工程指示 / 要求簡箋(E.I.)

工程指示編號：EI / 1575 / 20 修改版次：C
 工程編號：J851 工程名稱：青衣 明翹匯
 工程項目：確認模圖(後裝窗和趟門)
 收件人：羅小姐 發件人：Leung Hin Wai

現確認附頁模圖。共6頁。

CUSTOMER	HONGKONG CO.	CUSTOMER APPROVAL	CUST PART NO.	X85695
			SECTION NO.	LH0091113

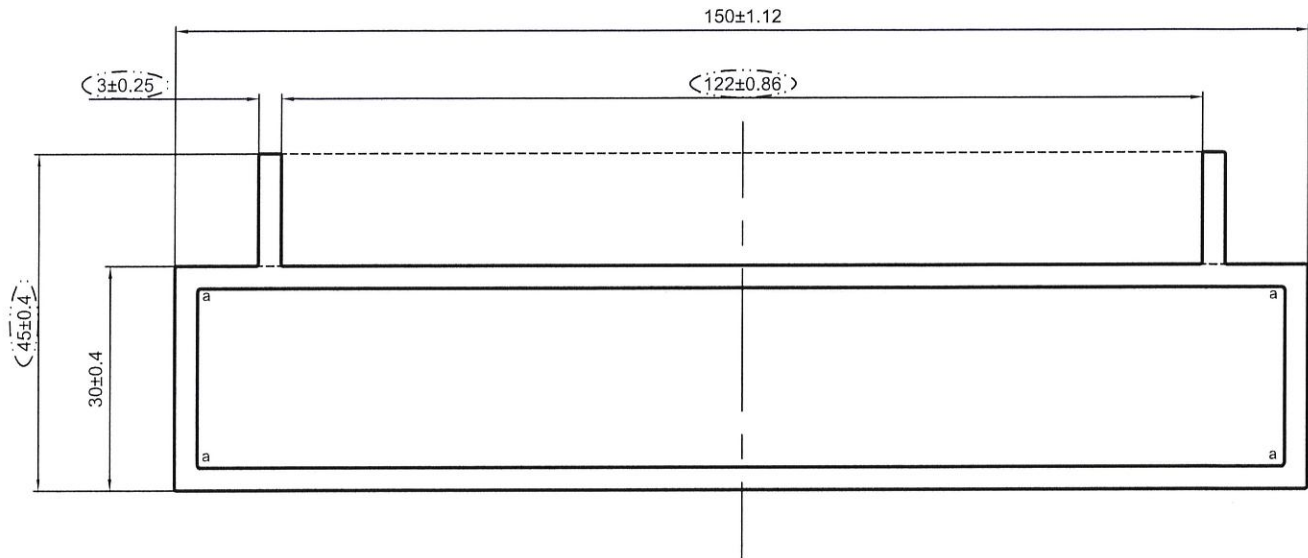
----- 次要装饰面，喷涂膜厚不足，但不露底
 ----- 装饰面

备注：没有配合型号！

CUSTOMER	HONGKONG CO.	CUSTOMER APPROVAL	CUST PART NO.	X85701
			SECTION NO.	LH0091144

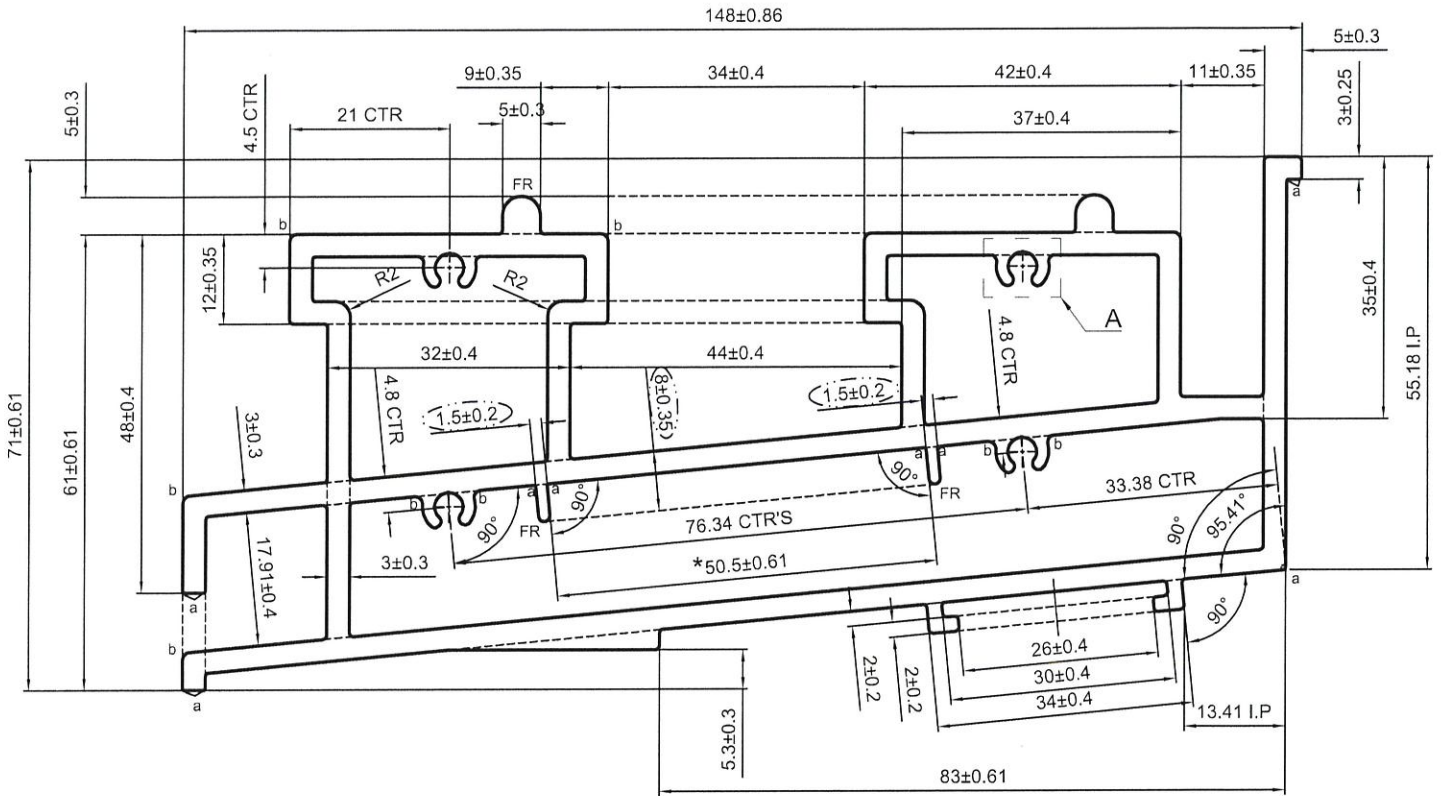
----- 次要装饰面, 喷涂膜厚不足, 但不露底

----- 装饰面

●●●●● 凹槽位置可能会有露底现象, 即膜厚不足

备注: 没有配合型号!

CUSTOMER	HONGKONG CO.	CUSTOMER APPROVAL	CUST PART NO.	X85699
			SECTION NO.	LH0091142

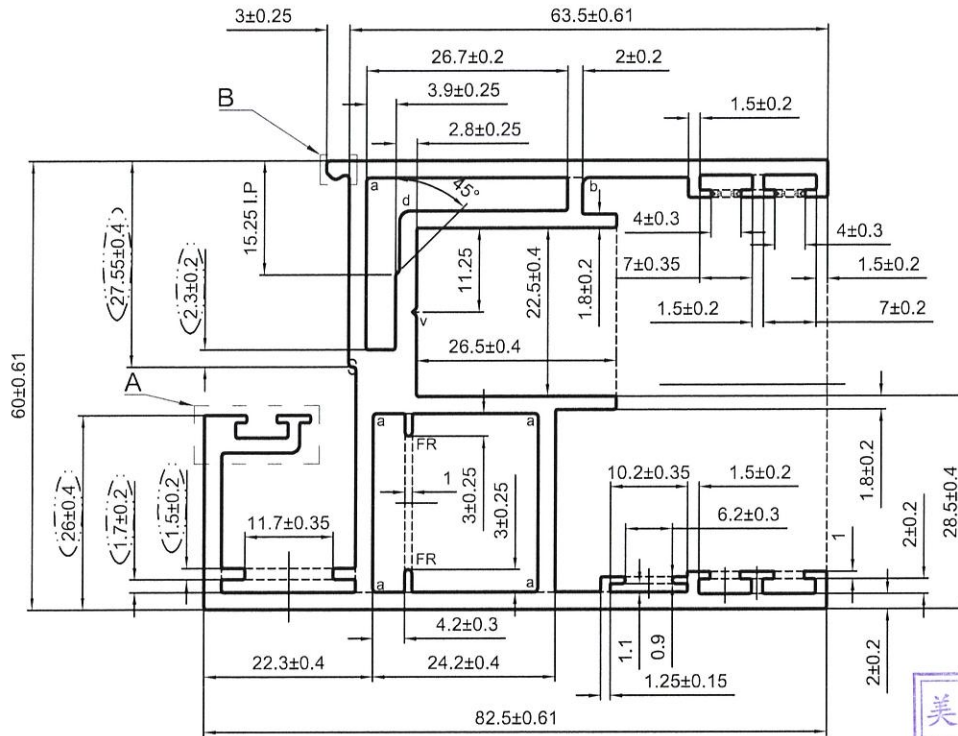
----- 次要裝飾面，噴塗膜厚不足，但不露底

----- 裝飾面

●●●●● 凹槽位置可能有露底現象，即膜厚不足

*配合尺寸以实物配合效果为准！

CUSTOMER	HONGKONG CO.	CUSTOMER APPROVAL	CUST PART NO.	X85700
			SECTION NO.	LH0091143

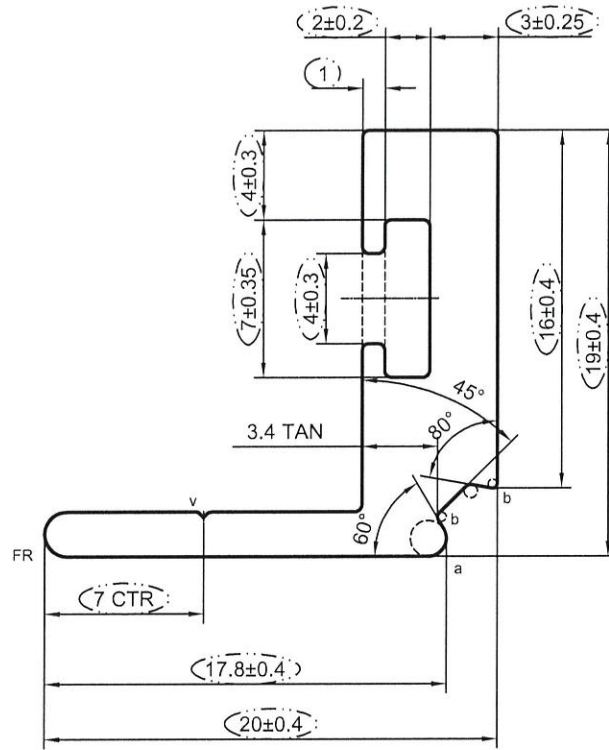
*配合尺寸以实物配合效果为准!

CUSTOMER	HONGKONG CO.	CUSTOMER APPROVAL	CUST PART NO.	X85780
			SECTION NO.	LH0091256

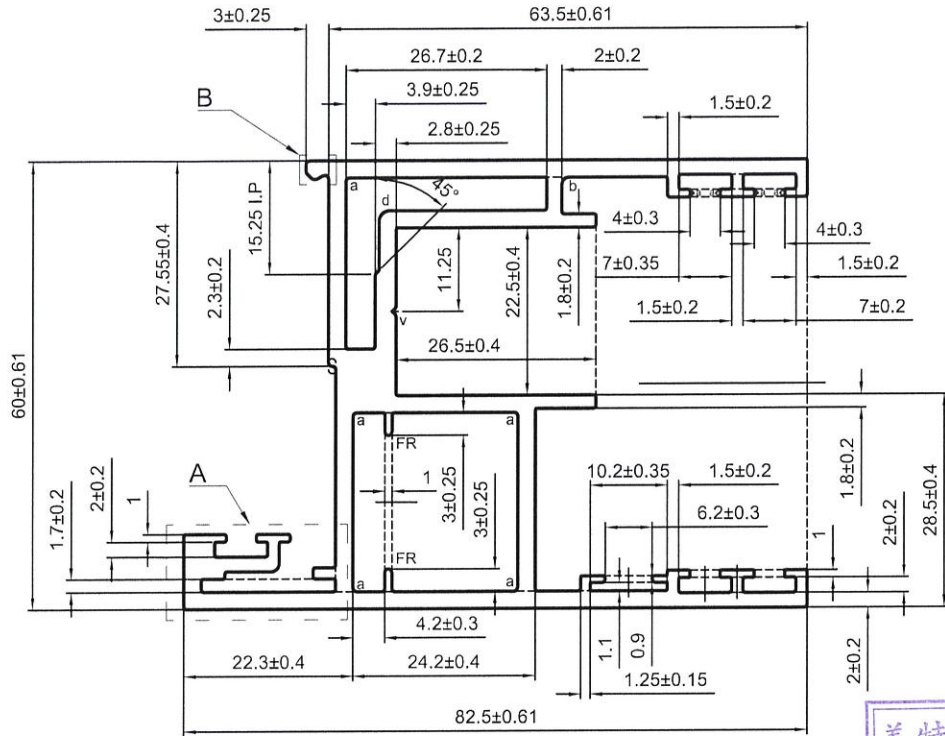
----- 次要裝飾面，噴塗膜厚不足，但不露底

----- 裝飾面

●●●●●● 凹槽位置可能會有露底現象，即膜厚不足

*配合尺寸以实物配合效果为准！

CUSTOMER	HONGKONG CO.	CUSTOMER APPROVAL	CUST PART NO.	X85703
			SECTION NO.	LH0091146

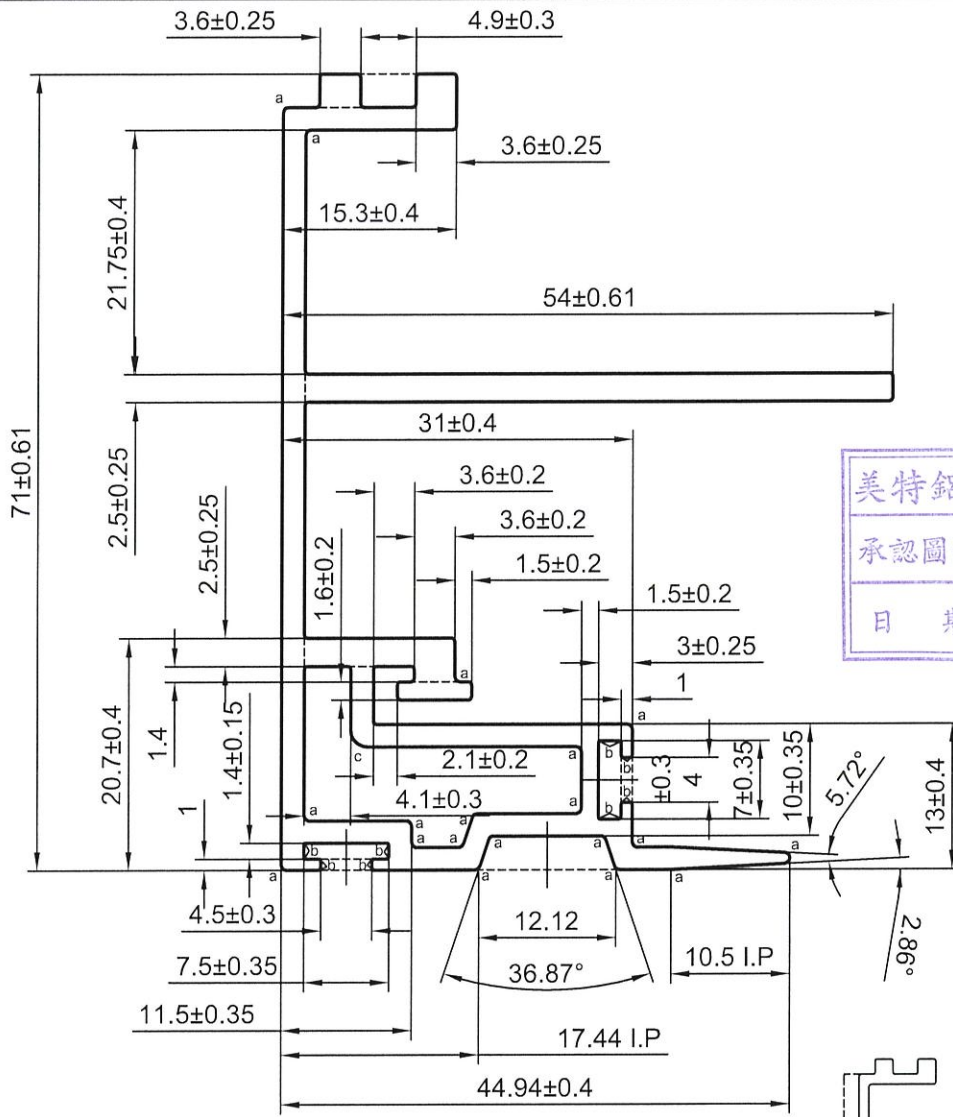
----- 次要裝飾面，噴塗膜厚不足，但不露底

----- 裝飾面

●●●●● 凹槽位置可能會有露底現象，即膜厚不足

*配合尺寸以实物配合效果为准！
